Amendments to the Drawings:

REMARKS

III. The Claimed Invention

FIG. 1a

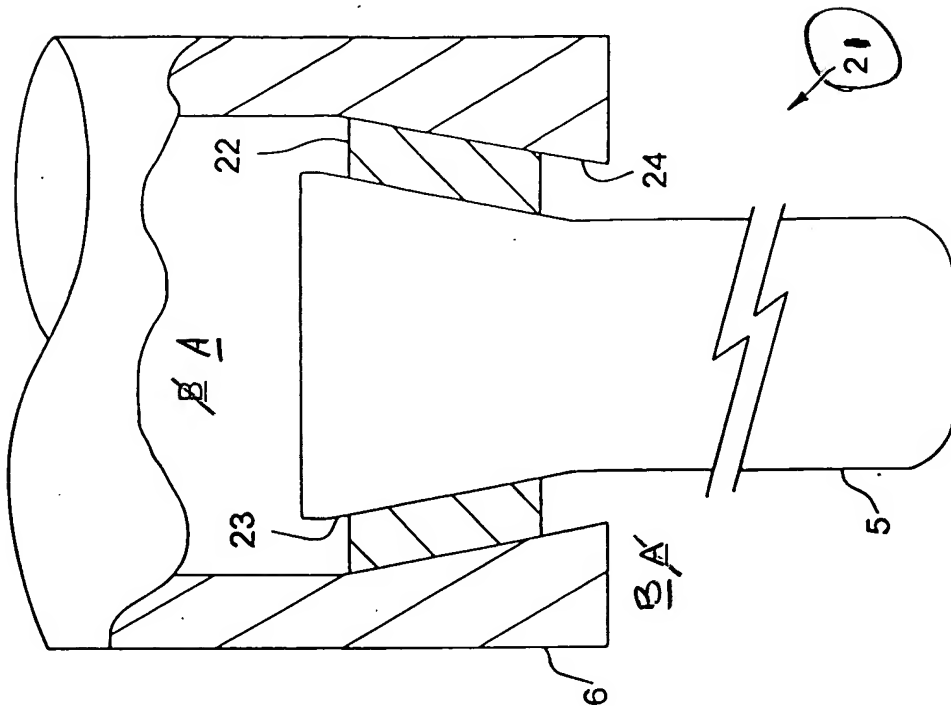
Attached hereto is a drawing labeled "Replacement Sheet" depicting a new FIG. 1a, which Applicants are requesting to substitute for the drawing sheet previously associated with FIGS. 1a and 1b as originally filed. Also submitted is a copy of a drawing sheet labeled "Annotated Mark-Up Drawing" showing the previous drawing sheet depicting FIGS. 1a and 1b, which sheet is marked to show the changes requested herein.

~~FIG. 1a~~

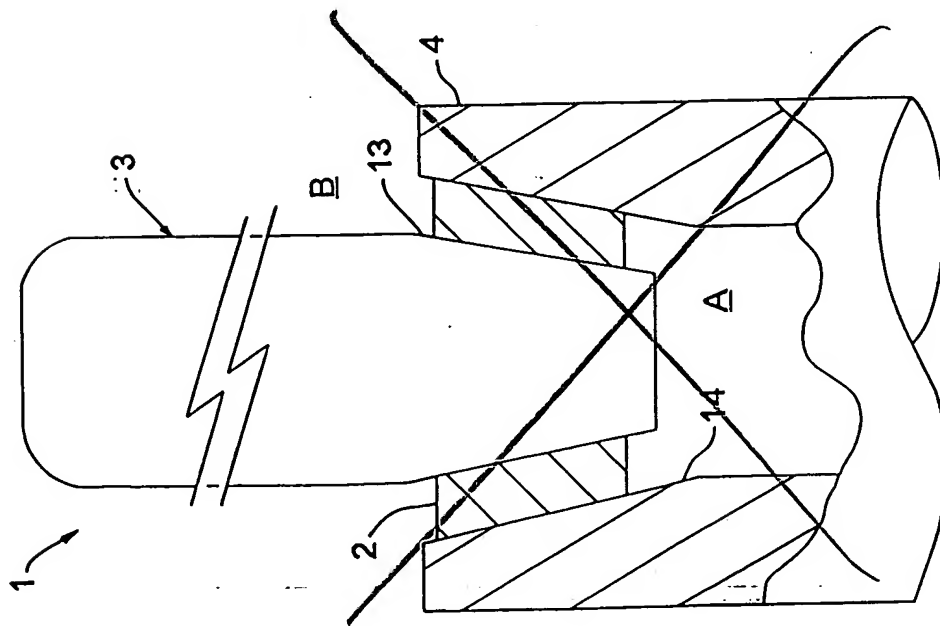
For the previous drawing depicting FIGS. 1a and 1b as originally filed (and as shown on the "Annotated Mark-Up Drawing"), Applicants are requesting to delete prior FIG. 1a as it appears redundant with FIG. 1 except for size, as noted in the Office Action. Applicants are also requesting that the remaining figure on the sheet be rotated 90 degrees and also relabeled as the new FIG. 1a. Further, Applicants are requesting that areas previously identified by "A" and "B" respectively, be reversed as also suggested by the Examiner in the Office Action. Reference numeral "2" has also been changed to – 21 – to avoid any potential confusion with reference numeral "2" also appearing on FIG. 1.

Applicants have herein requested amendment of the drawing sheet previously depicting FIGS. 1-a and 1-b, so that FIG. 1-a as originally submitted is deleted, and that FIG. 1-b as originally submitted is rotated 90 degrees and relabeled as "FIG. 1-a". Applicants have also requested that joint "2" on the previous drawing sheet be amended to a new reference numeral – 21 --, so minimize confusing that might arise relative to FIG. 1, which uses the reference numeral "2" in relation to the girdle member. Applicants have also reversed the locations identified as "A" and "B" on new FIG 1-a, to be consistent with use in FIG. 1. However, Applicants wish to point out that the use of the letters "A" and "B" in the original figures was reversed intentionally, in that location "B" was deemed to be an area of higher pressure relative to area "A". Appropriate amendments in the Specification, as

Rotate
90°
